Rezoning Transportation Analysis

Petition Number: 2022-118

Revision Log:	Date	Description
	12-29-22	First Review (IW)
	01-26-23	Second Review (IW)

Reference (CLDSM standard detail U-04.16) for street typical for public roads.

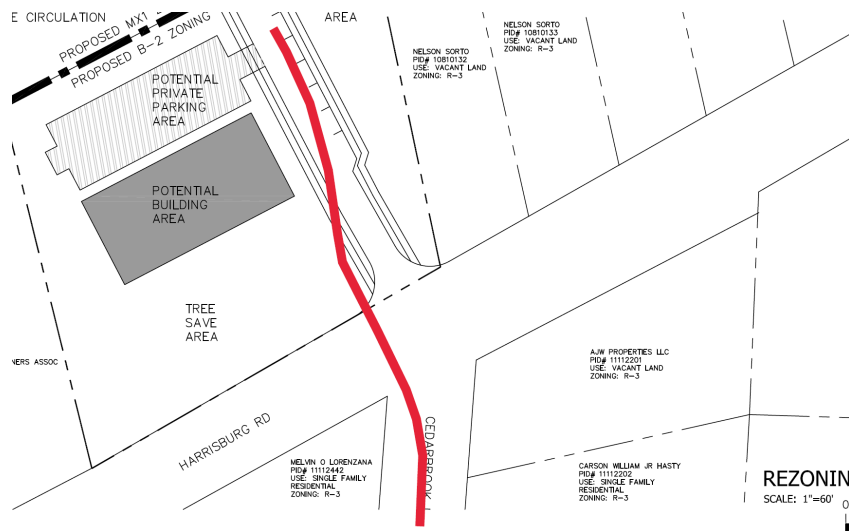
- 3. Revise site plan and conditional note(s) to commit to dedicate 52 feet of right-of-way from the road centerline. The site plan shall label and dimension the right-of-way from the road centerline.
- 4. Per Chapter 20 revise site plan and conditional note(s) to commit to construct an 8-foot planting strip, and 6-foot sidewalk on all internal public roads or if the proposed dwelling units exceeds 12 per acre after verifying density, revise site plan and conditional note(s) to commit to construct an 8-foot planting strip, and 8-foot sidewalk along all internal public Roads. The wider sidewalk also meets the Charlotte WALKS Policy.

The site plan shall label and dimension both items from the back of curb and gutter or edge of pavement.

Clarifying comment 01-26-23: After receiving updated density, the site plan and conditional note(s) should be revised to commit to construct an 8-foot planting strip, and 6-foot sidewalk on all internal public roads per the Chapter 20 ordinance.

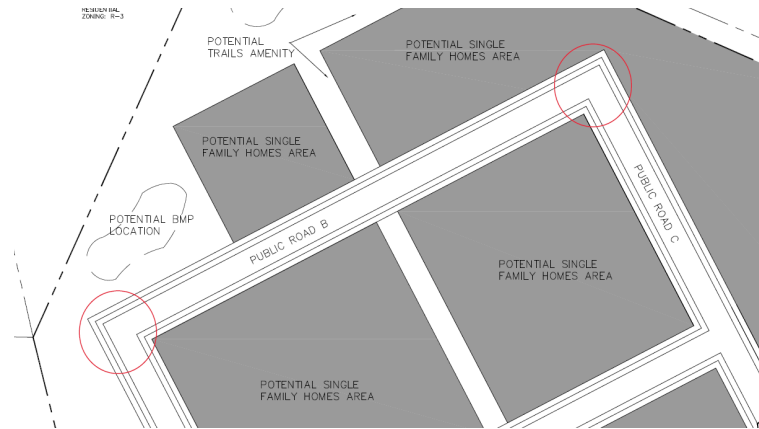
11. Revise design of public roads to remove 90 degree turns.
